Condition B2

LORETO NORMANHURST **BOARDING HOUSE**

91-93 PENNANT HILLS NORMANHURST NSW

5 DA3103

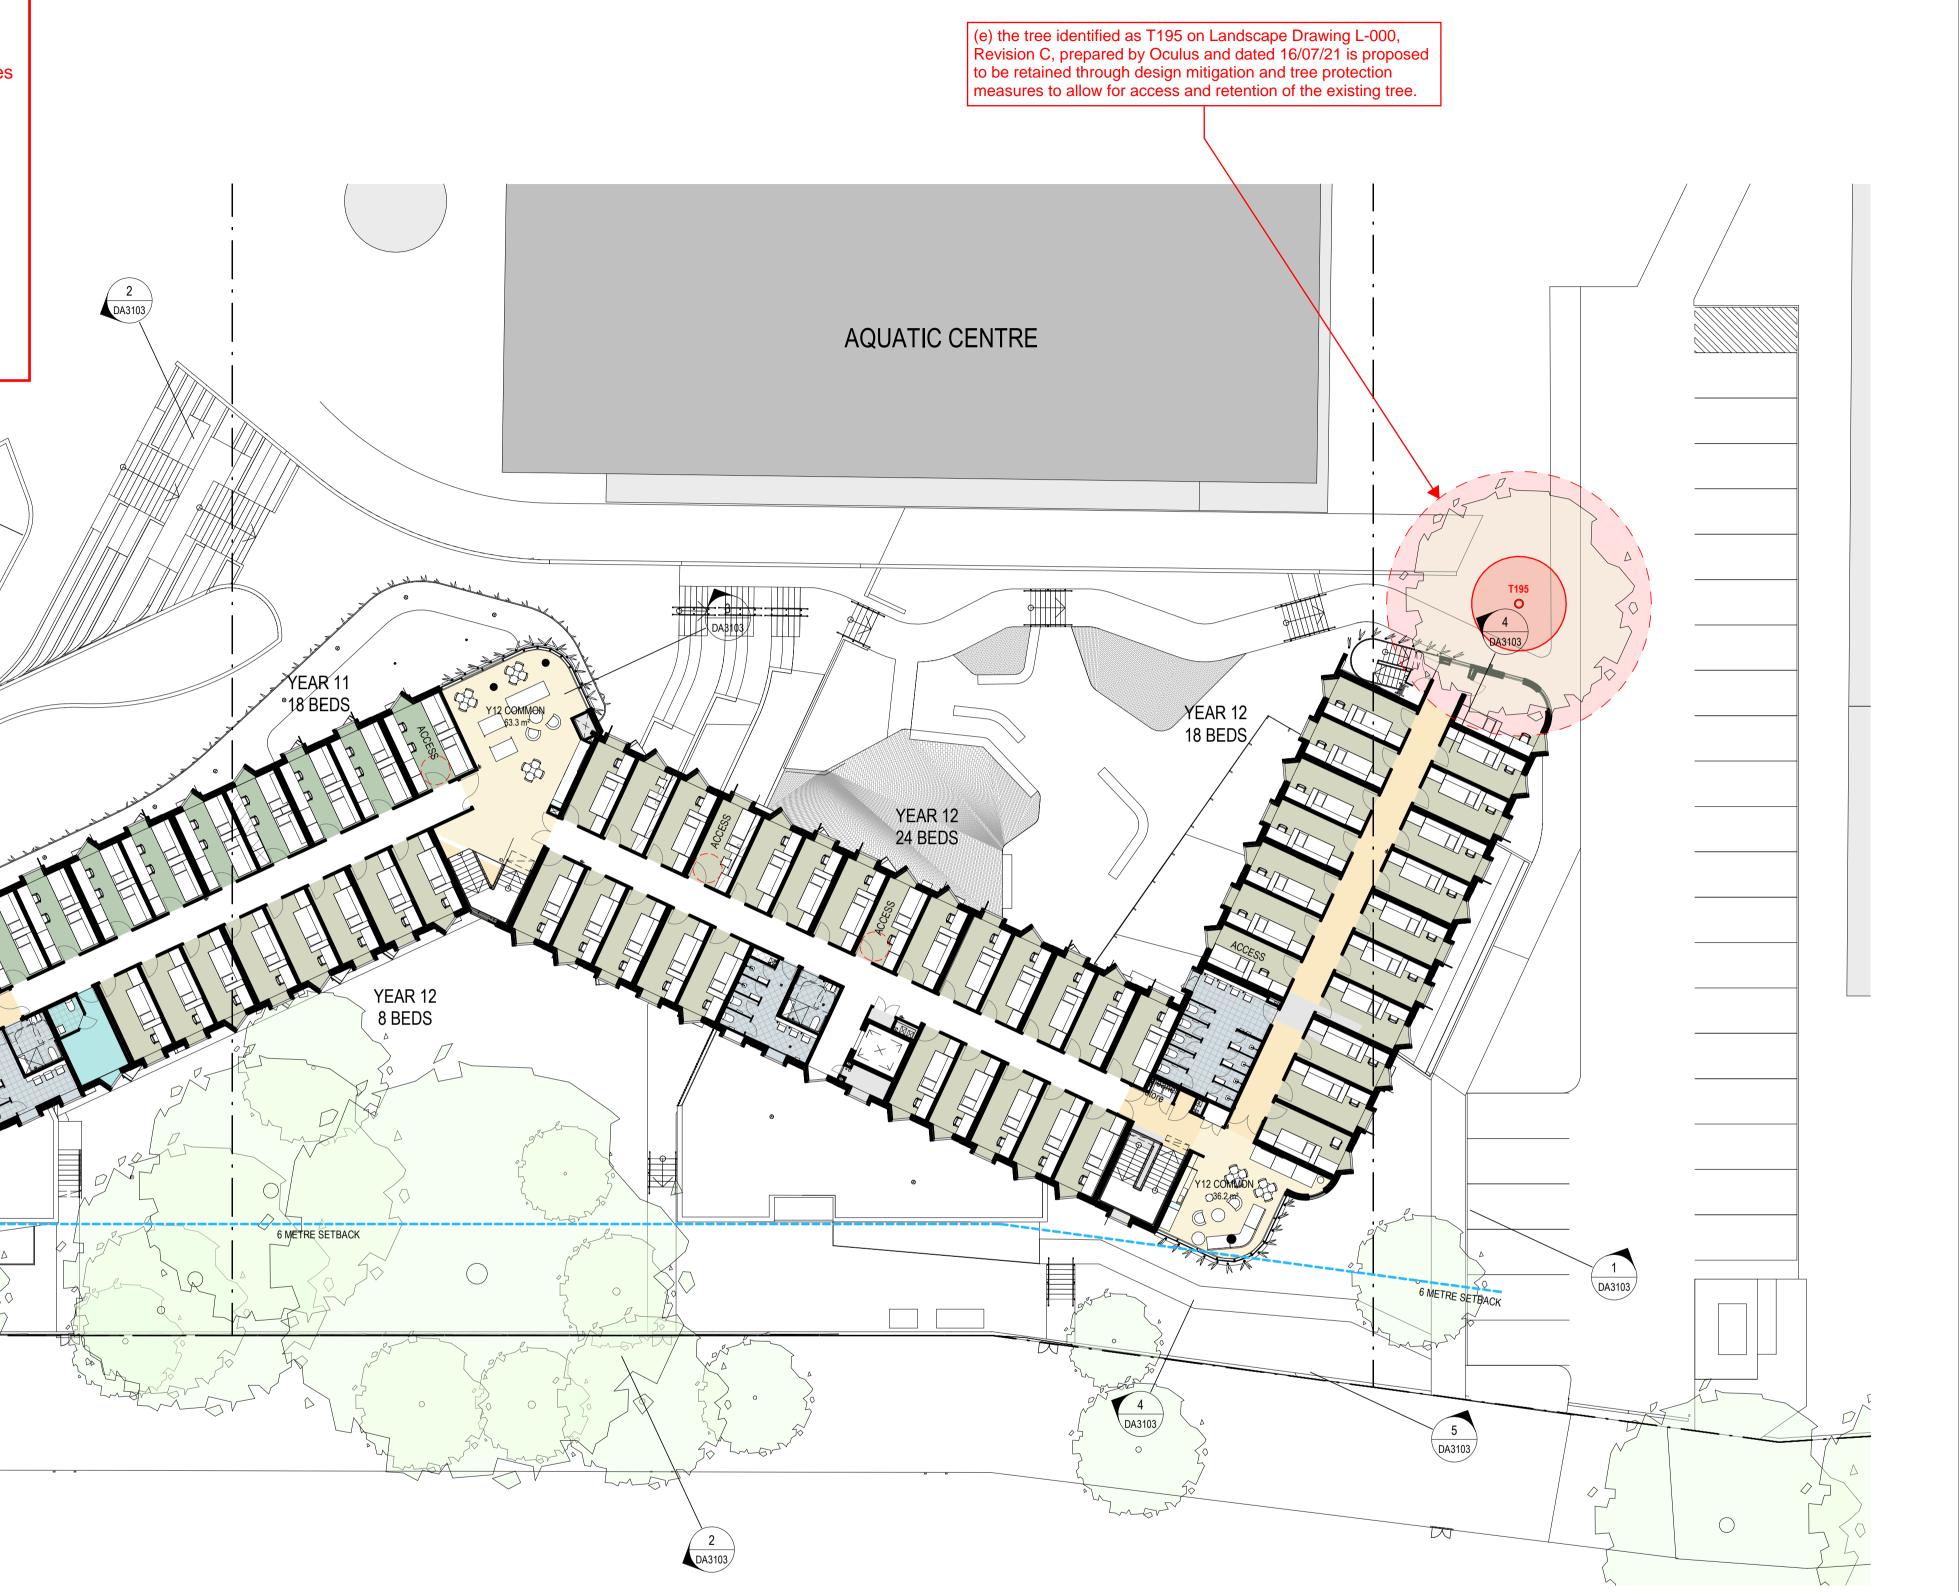
Prior to the issue of any construction certificate for Stage 1, the approved architectural and landscape plans listed in Schedule 3 condition A2 relating to the boarding accommodation building must be amended to incorporate the following changes to the design of the boarding accommodation building to the satisfaction of the Planning Secretary:

(a) the at-grade waste collection area including associated hard stand areas and separate driveway must be deleted and the existing trees

in this location (Tree Nos. 227, 321, 323, 324, 328, 331, 335, 336 and 337 as identified on the landscape plans must be retained;

- (b) the design of the basement must be amended to enable the trees listed in (a) above to be retained;
- (c) the waste collection area must be relocated to the basement;
- (d) the design of the basement, including ceiling clearance and turning circle, must be redesigned to enable a waste collection vehicle to enter and exit the basement in a forward direction;
- (e) the redesigned basement required by (b) above must not result in the removal of any other existing trees; and the tree identified as T195 on Landscape Drawing L-000, Revision C, prepared by Oculus and dated 16/07/21 must be retained through design mitigation and tree protection measures to allow for access and retention of the existing tree.
